WATER QUALITY MEMORANDUM

Utah Coal Regulatory Program

RE: 2007 Third Quarter Water Monitoring, PacifiCorp, Trail Mountain Mine, C/015/0009, Recurring Task ID #2713

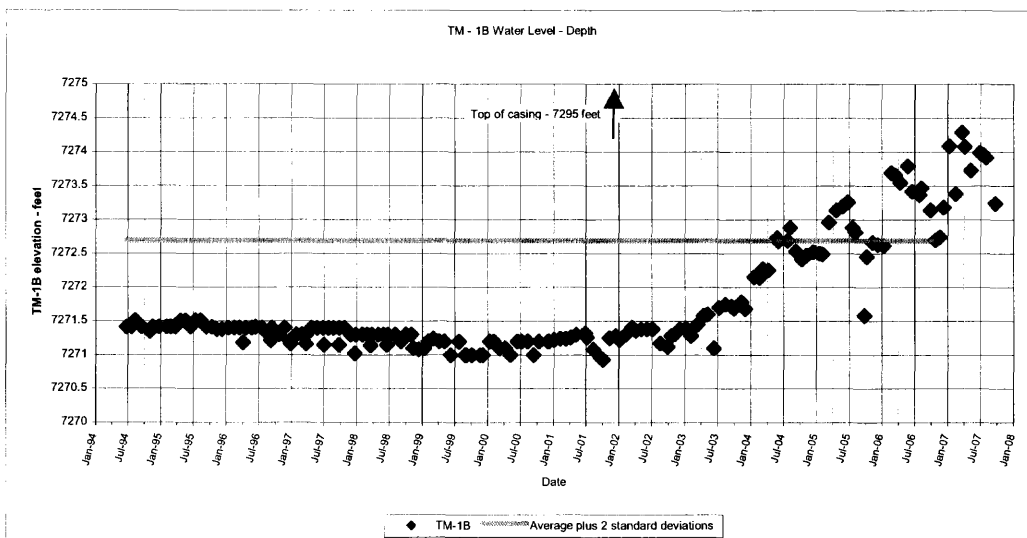
TM-3: water elevation peaked in June 2005, remained steady through October, dropped 18.5 ft in November and December 2005 and remained virtually unchanged during 2006. The pressure gauge was replaced in January 2007 and values jumped to approximately match the pre-2006 curve. During the first half of 2007, the curve was relatively flat, but it resumed climbing during the third quarter. See the chart below.

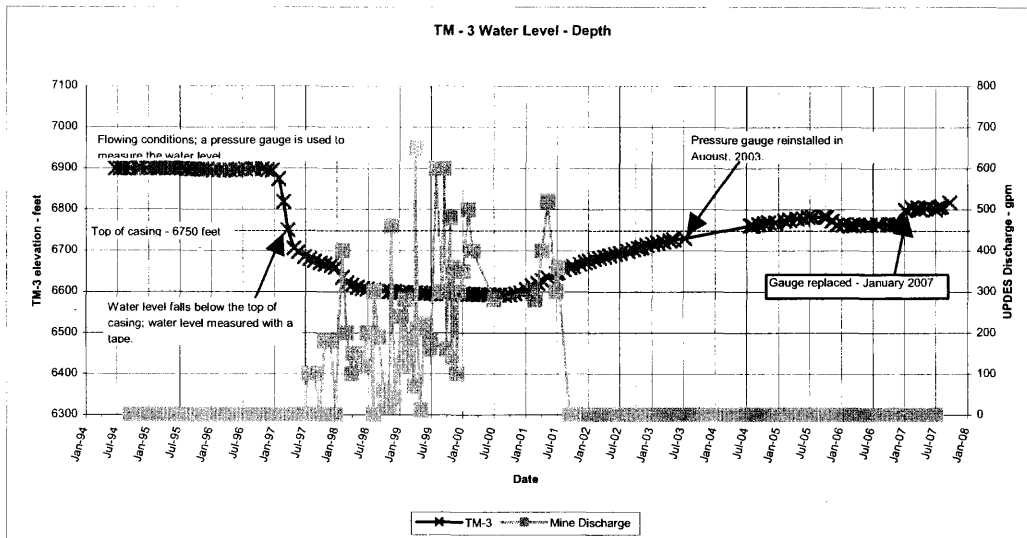
TM-1B July and August: depth. Water level rose slowly beginning in 2003, but appears to have peaked in early 2007 and to be declining. See the chart below.
